**MASTER PLAT
PEACHTREE MEADOWS**

PROJECT NUMBER: P2023-016
PROJECT NAME: Master Plat for Peachtree Meadows
SITE ADDRESS/LOCATIONS:

CASE CAPTION: Discuss and consider a request by Meredith Joyce on Michael Joyce Properties on behalf of John Vick of Qualico Development, Inc. for the approval of a Master Plat for the Peachtree Meadows Subdivision consisting of 292 single-family residential lots on a 140.50-acre tract of land identified as Tract 5 of the J. R. Johnson Survey, Abstract No. 128 and Tract 3 of the G. Wells Survey, Abstract No. 219, City of Rockwall, Rockwall County, Texas, zoned Planned Development District 101 (PD-101) [Ordinance No. 23-11] for Single-Family 10 (SF-10) District land uses, generally located on the southside of Mims Road west of the intersection of Mims Road and National Drive, and take any action necessary.

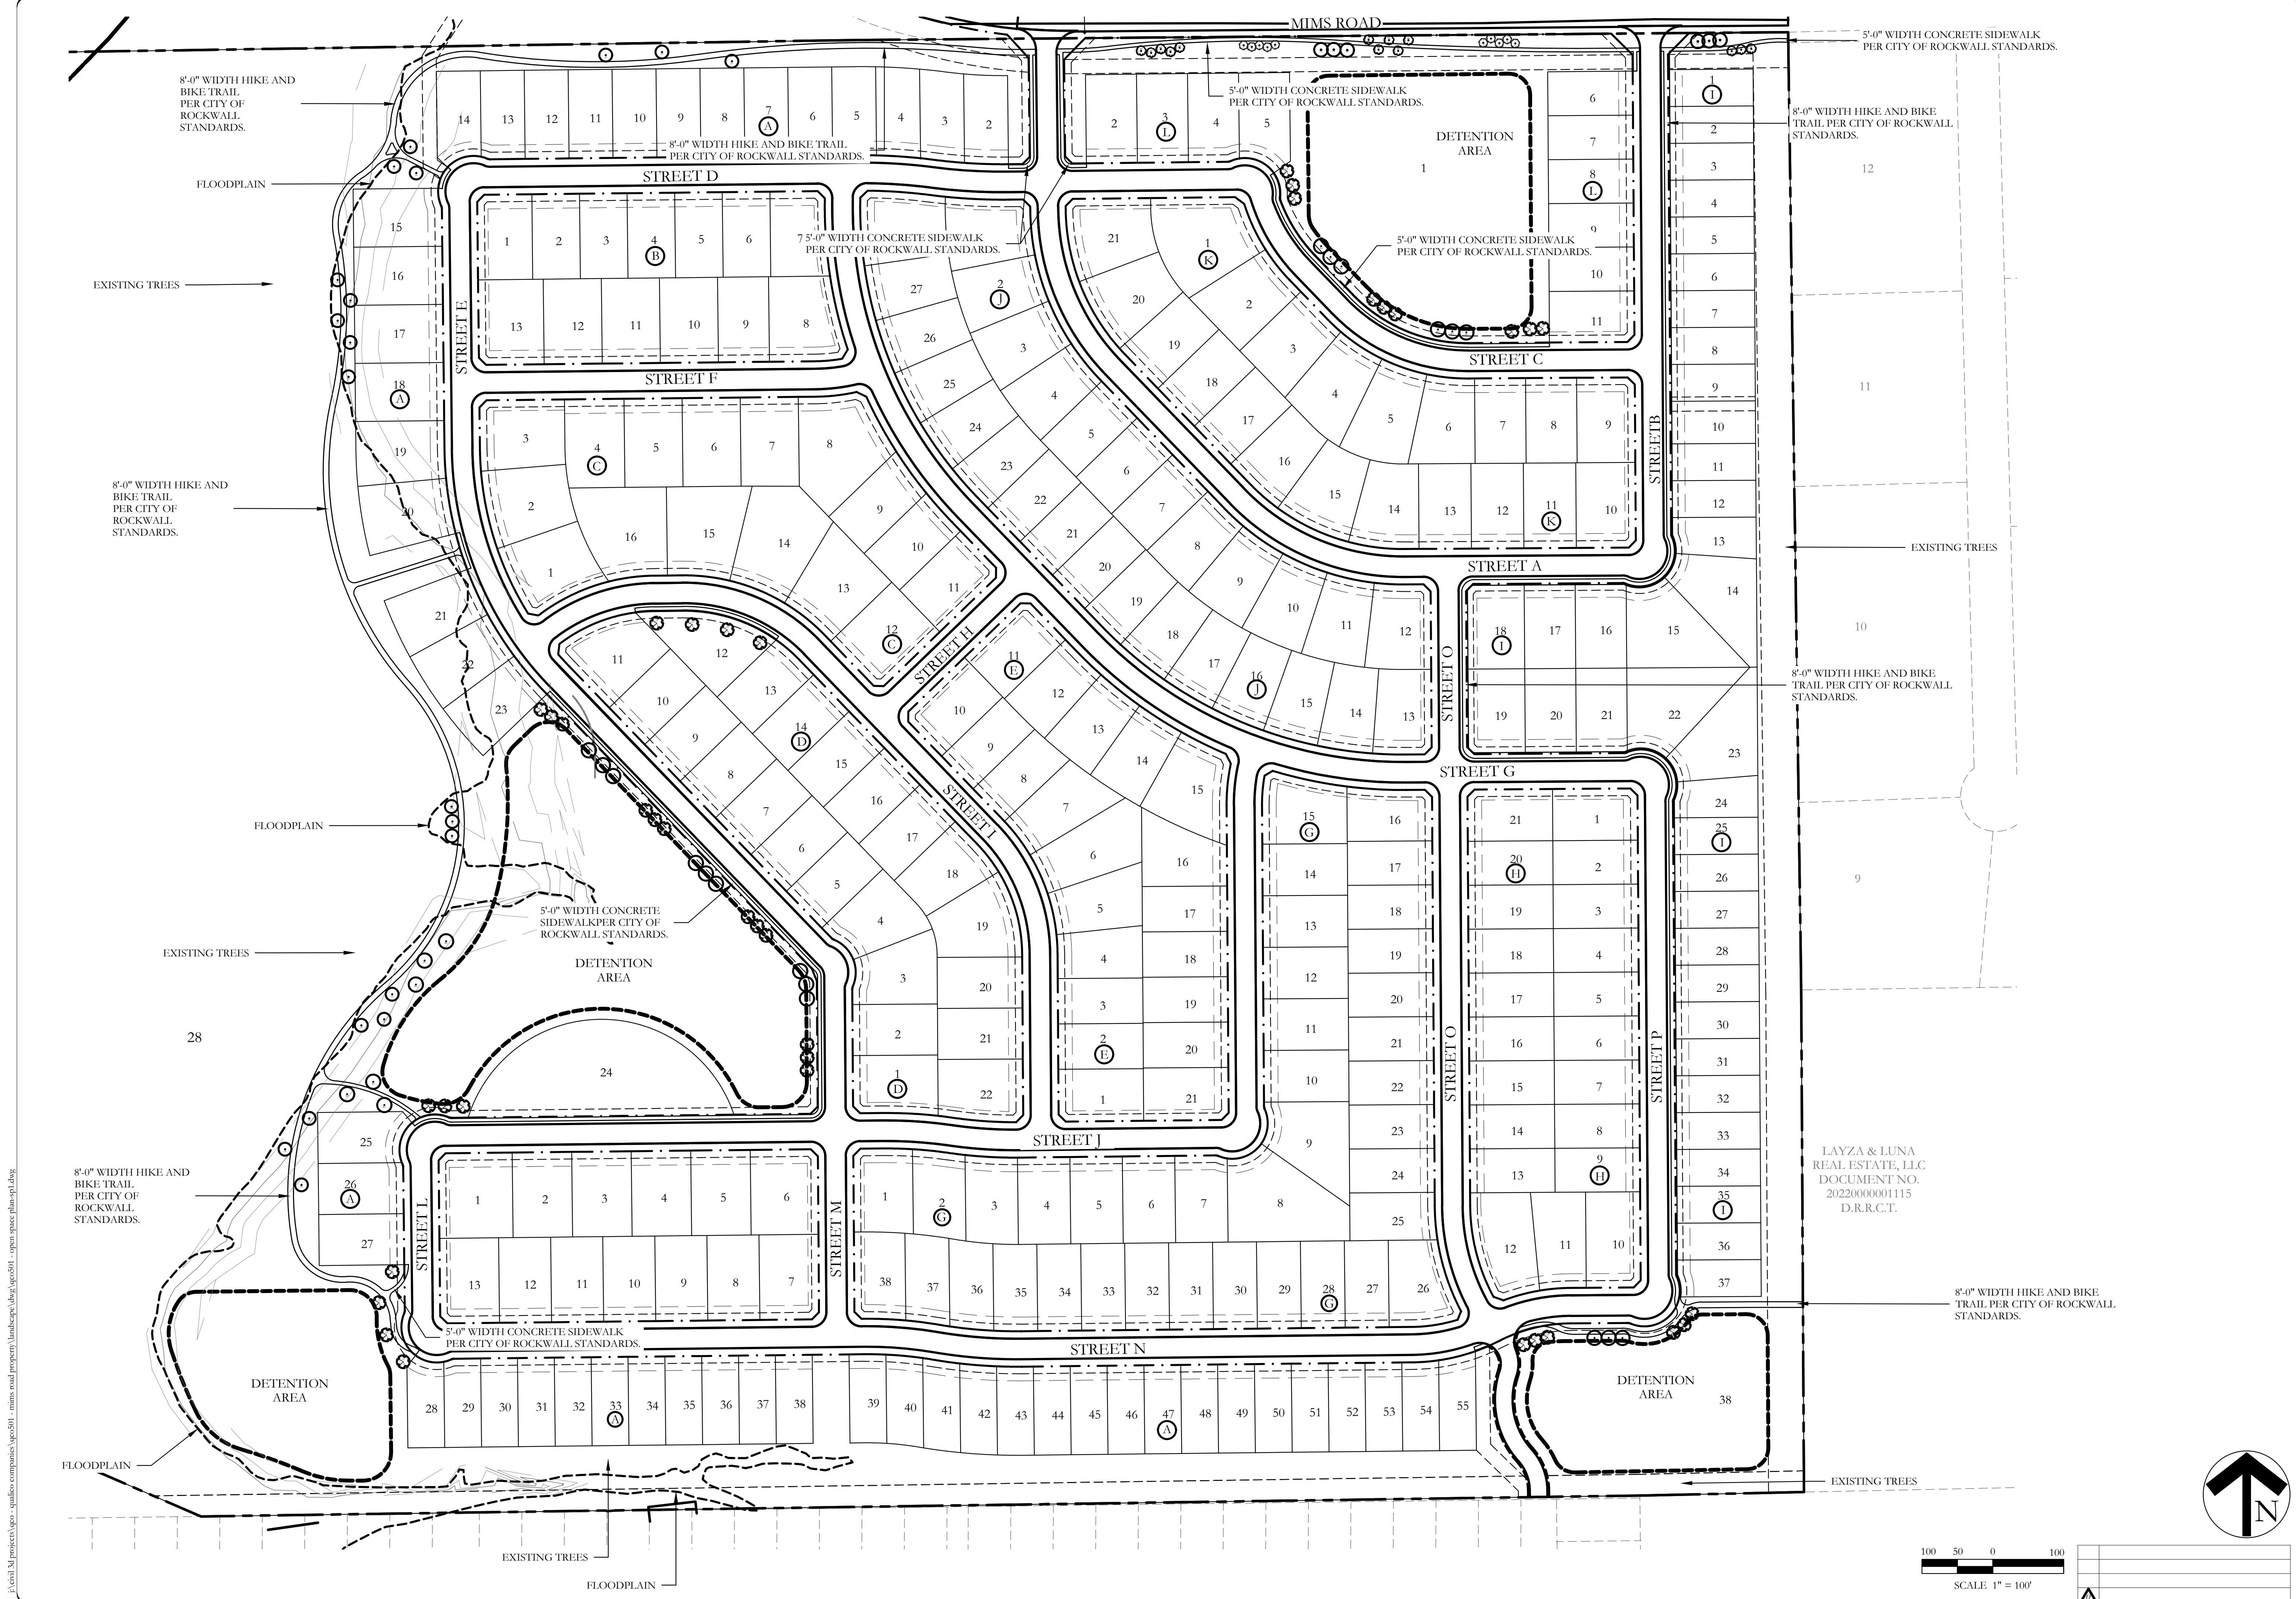
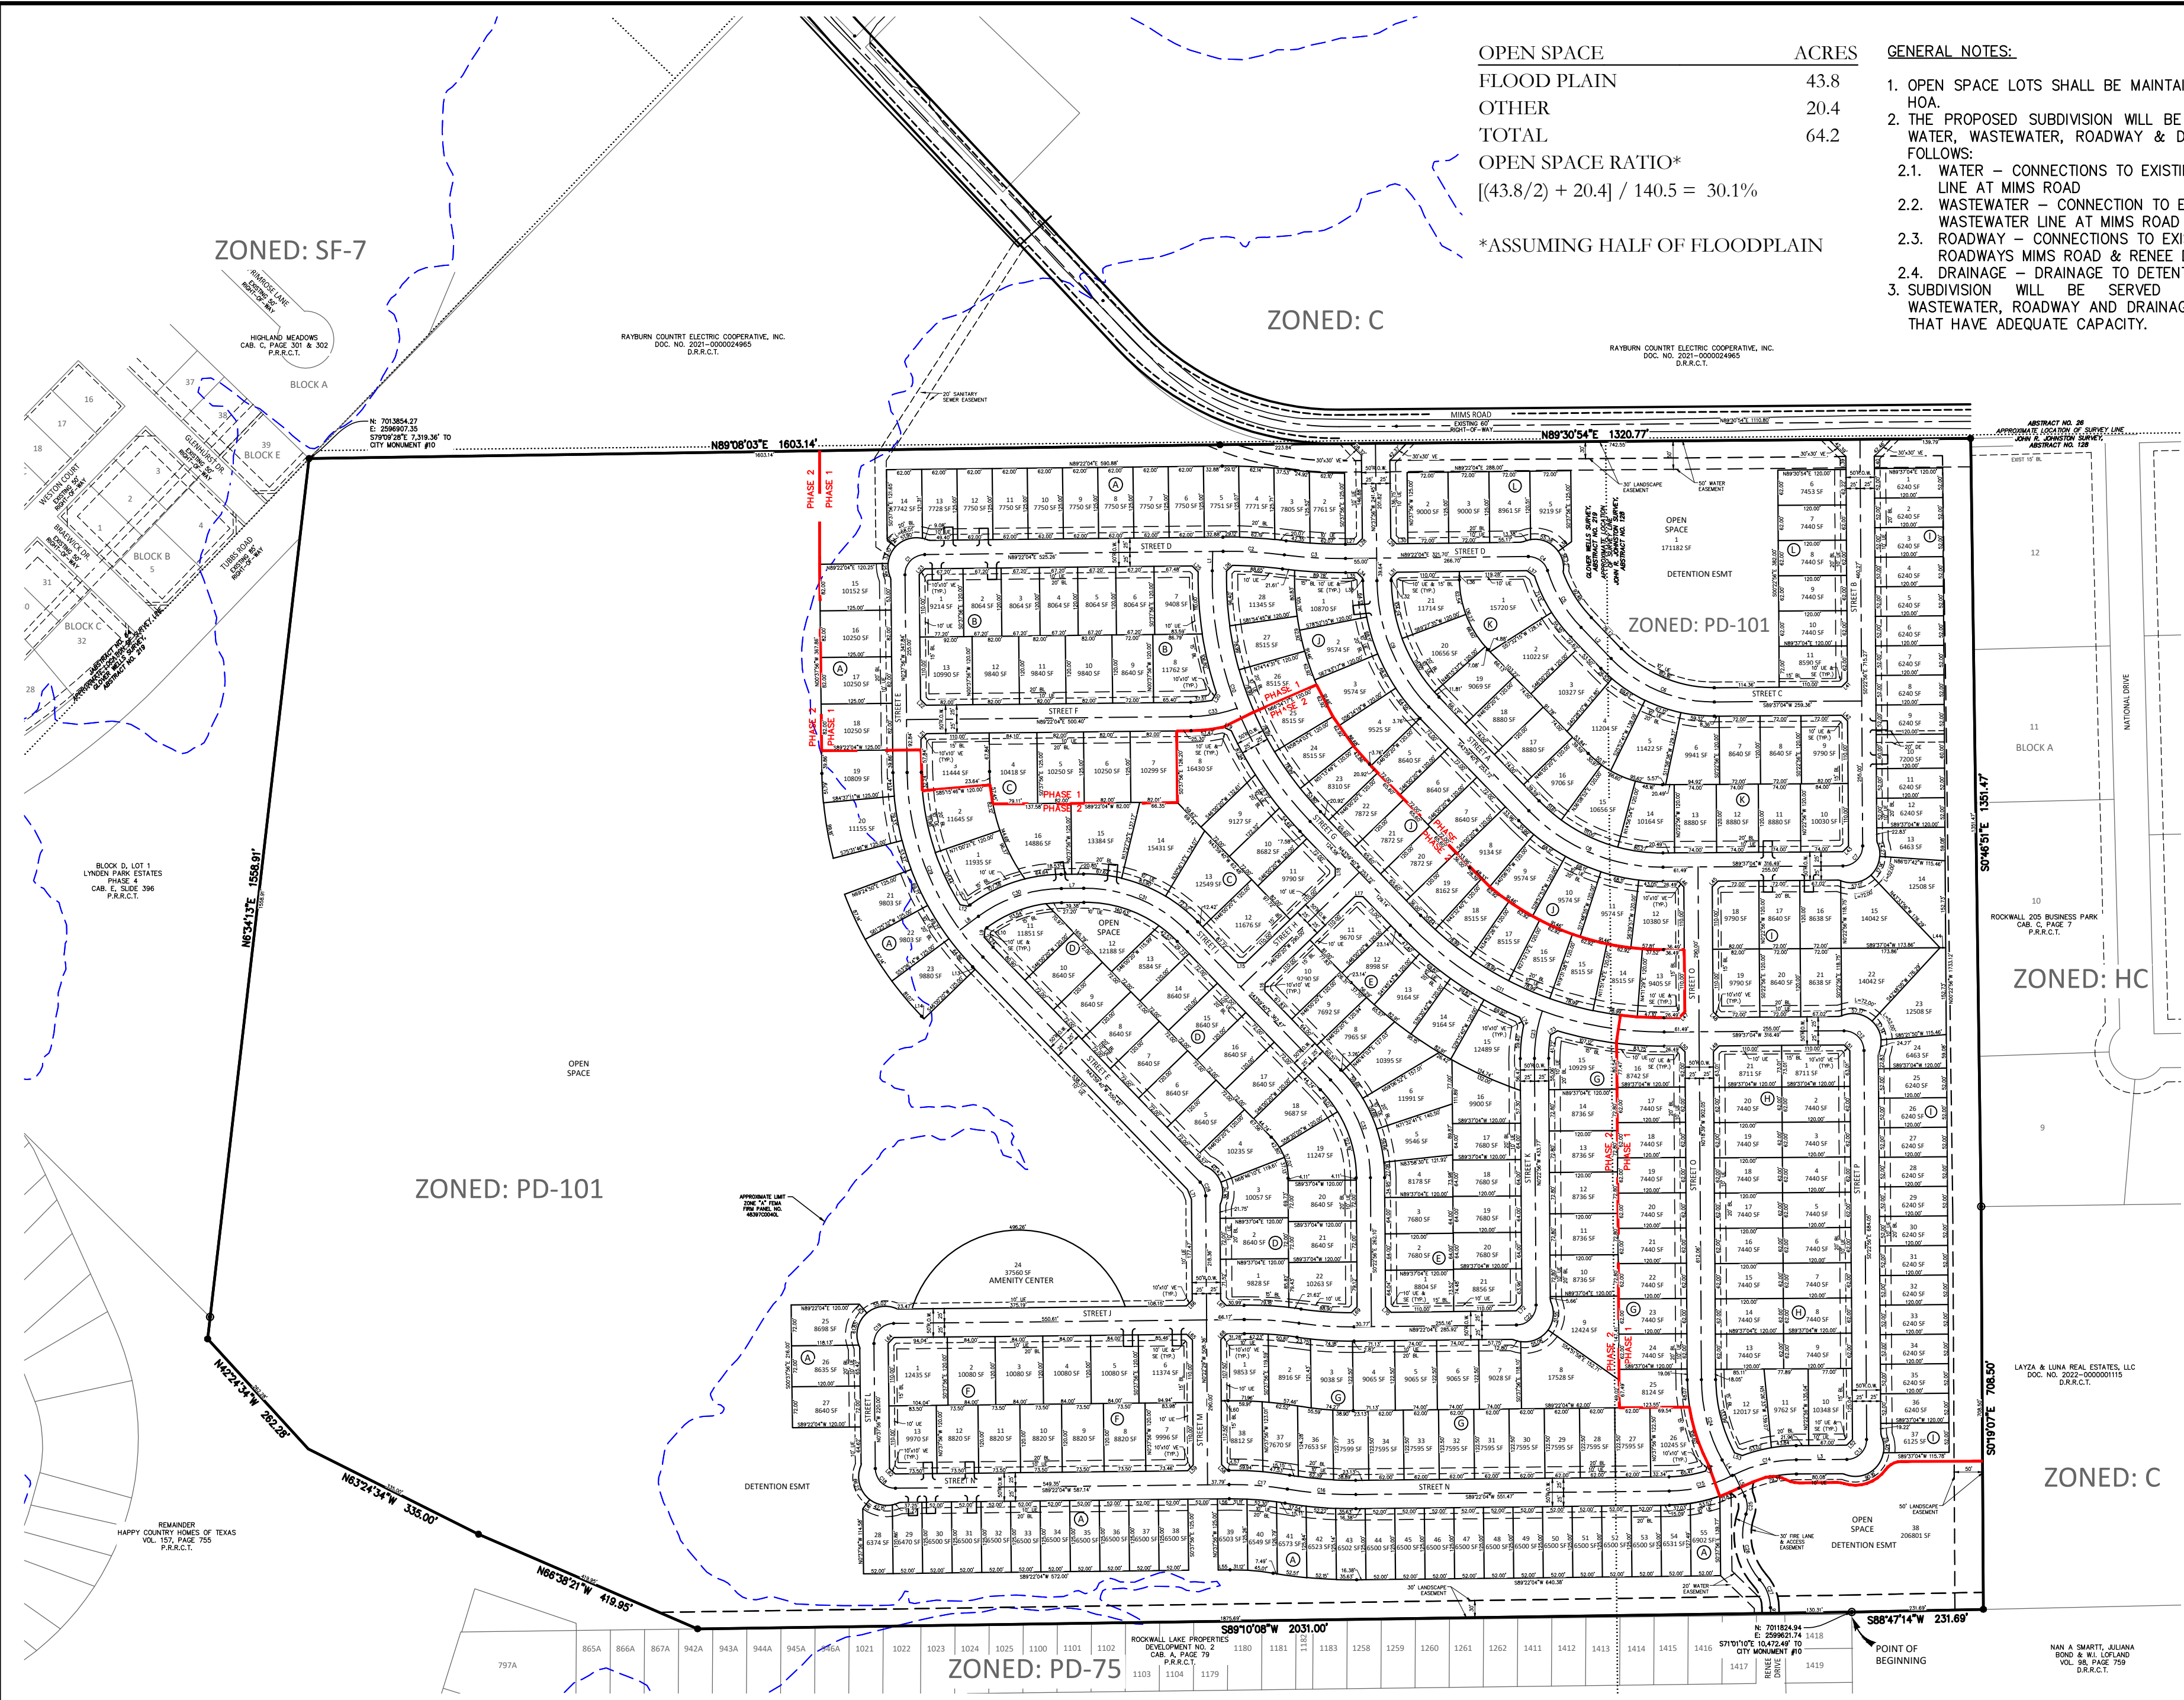
M.3 For reference, include the case number (P2023-016) in the lower right-hand corner of all pages on future submittals.

M.4 The Title Block should read as follows (Section 38-7, Subdivision and Platting Procedures, of the Municipal Code of Ordinances):

M.5 Please remove the lot and block information from each lot. (Section 38-7, Subdivision and Platting Procedures, of the Municipal Code of Ordinances)

M.6 Please provide the lot density for the gross acreage. (Section 38-7, Subdivision and Platting Procedures, of the Municipal Code of Ordinances)

M.7 Please provide the street names. (Section 38-7, Subdivision and Platting Procedures, of the Municipal Code of Ordinances)

M.8 Please provide the topographic contours, the 50-year and 100-year flood elevations, and indicate the wooded areas. (Section 38-7, Subdivision and Platting Procedures, of the Municipal Code of Ordinances)

M.9 Please indicate the land use as Single-Family 10 (SF-10) District. (Section 38-7, Subdivision and Platting Procedures, of the Municipal Code of Ordinances)

Master Plat
Peachtree Meadows Subdivision
Being
292 Residential Lots, 4 Open Space Lots, & 1 Amenity Lot
140.494-Acres or 6,119,939 SF
Situated in
G. Wells Survey, Abstract No. 219 &
J. R. Johnston Survey, Abstract No. 128
City of Rockwall, Rockwall County, Texas
